# PERMIT

## SEWAGE DISPOSAL SYSTEM

SUBDIVISION Walnut Springs LOT 8 ROAD 1254 Emmaus Road

RE: Building Permit #B00100161  
Walnut Springs - Lot 8

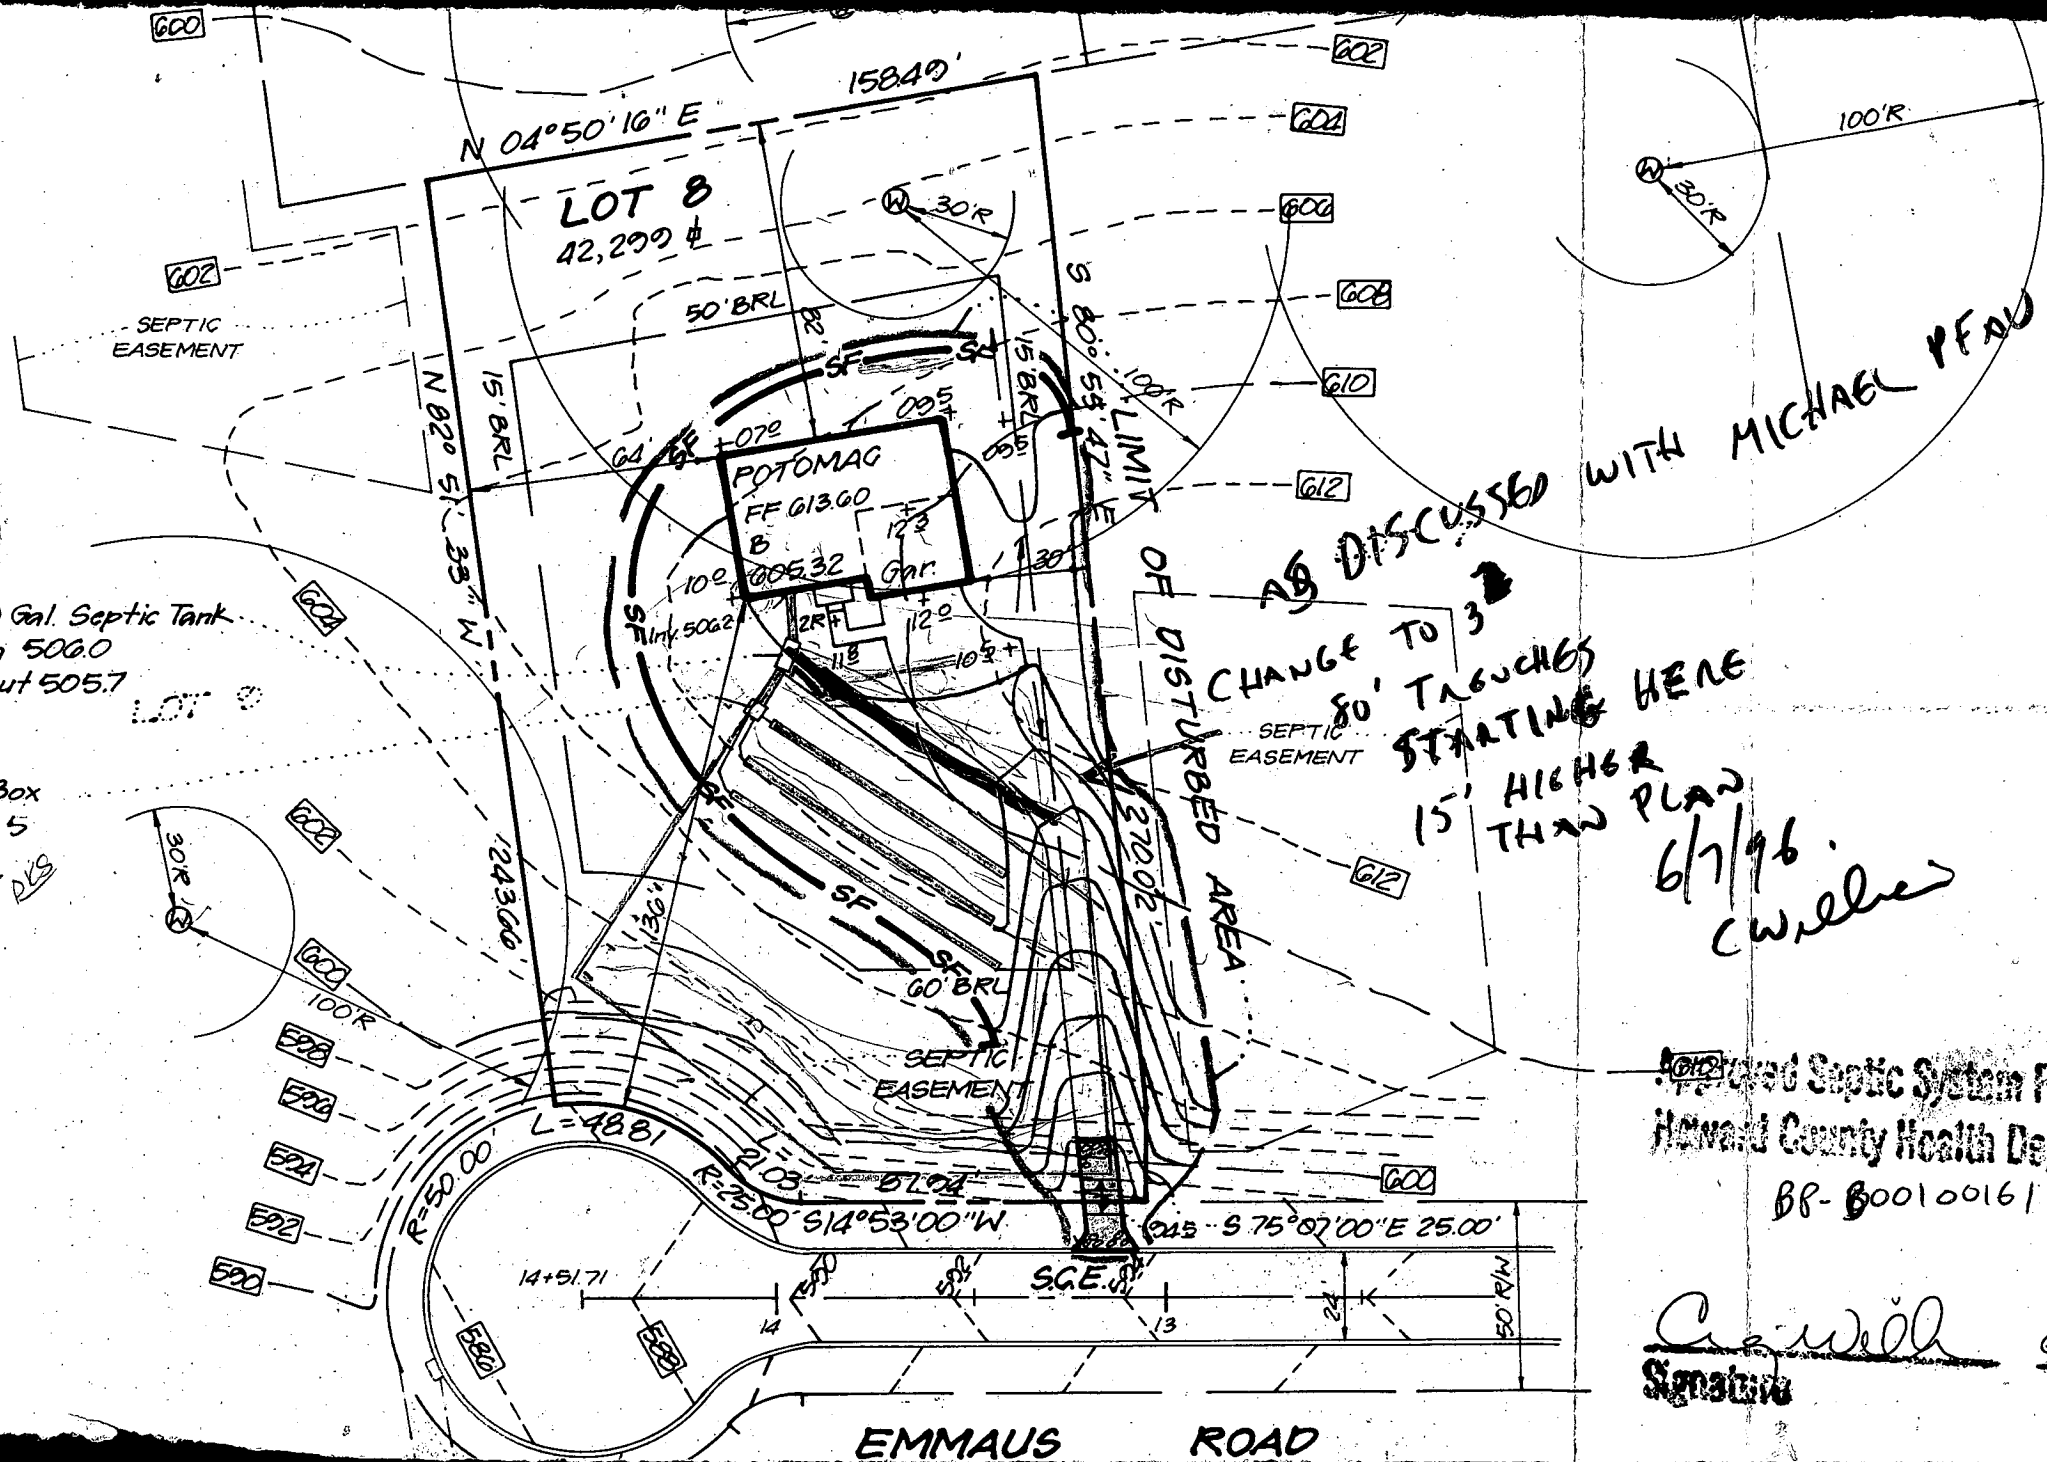
1. Road grading has already impacted the lower portion of the septic area, the proposed driveway will further reduce area available for septic system installation.
2. Little room exists for revision of the septic area.

We would request a review conference to determine how best to utilize the site.

BUILDER AGREES TO  
INSTALL SYSTEM 15' H1646  
ON LOT THAN ~~PLAN~~ SHOWN OF BP PLAN  
WILL DO THIS PRIOR TO FINAL DRIVEWAY  
CONSTRUCTION AND EARLY ENOUGH IN  
HOUSE CONSTRUCTION PROCESS TO ADAPT TO  
WHETHER OR NOT GRAVITY BASEMENT SERVICE

Approved Septic System Plan  
Howard County Health Department  
BP-000100161

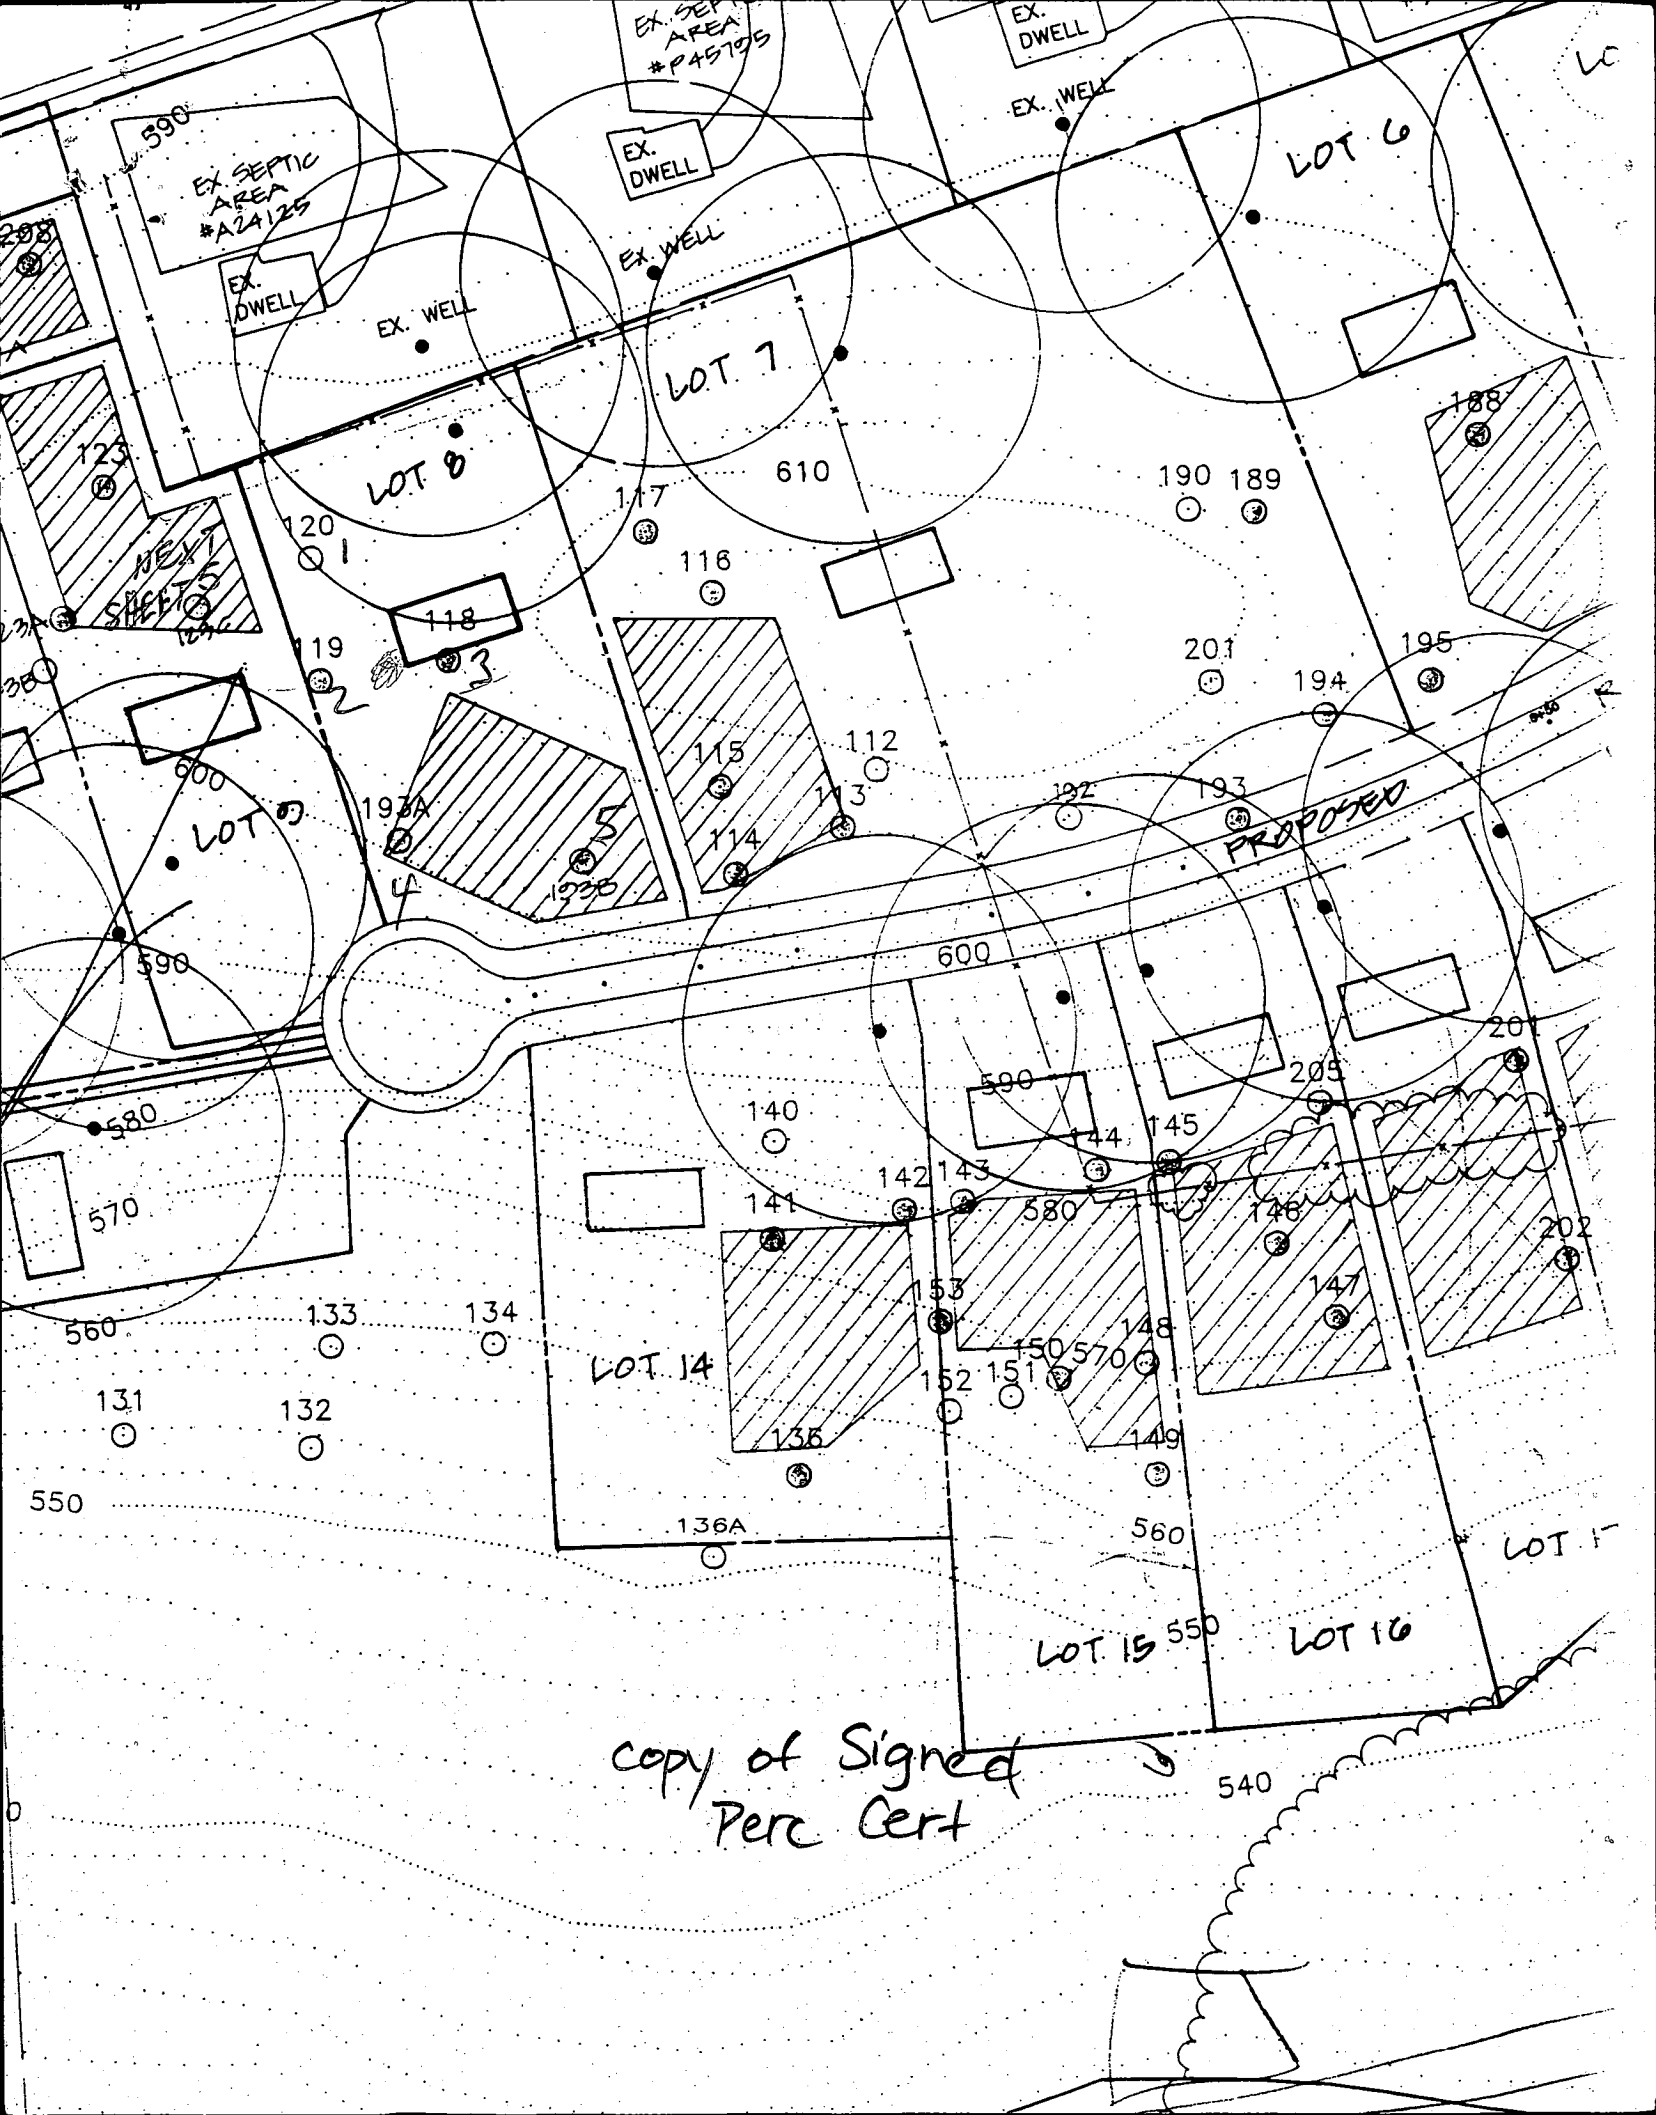
CHANGE TO 3  
80' TRENCHES  
STARTING HERE  
15' HIGHER  
THAN PLAN
